P R O D U C T I O N M E M O

INSTRUMENT: Model 8690B Sweep Oscillator, serials between 959-01651 and 959-01901.

SUBJECT: POSSIBLE SAFETY HAZARD.

INSTRUMENT: Model 8690B Sweep Oscillator
Serials 921-01050 through 959-02071SUBJECT: RECOMMENDED REPLACEMENT FOR 500 K Ω RESISTORS**ACTION REQUIRED:**

Figure 1. Rear Panel of 8690B with new IEC Power Plug (serials above 959-01651)

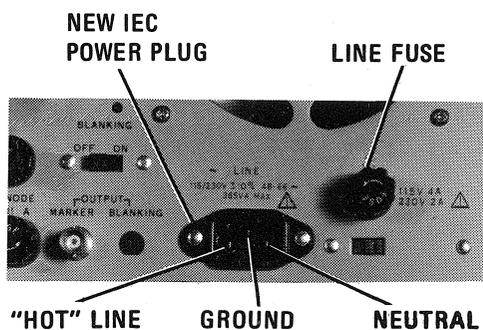
All 8690B Sweep Oscillators, serials between 959-01651 and 959-01901, should be checked to determine that the primary power wiring on the rear panel is wired correctly.

- (1) The line fuse and the line switch should always be wired on the "hot" side of the 115V ac line.
- (2) With an enclosed fuse holder, the "hot" power lead should be connected to the center terminal at the rear of the fuse holder.

The "hot power line on these 8690B's can be identified from the figures below.
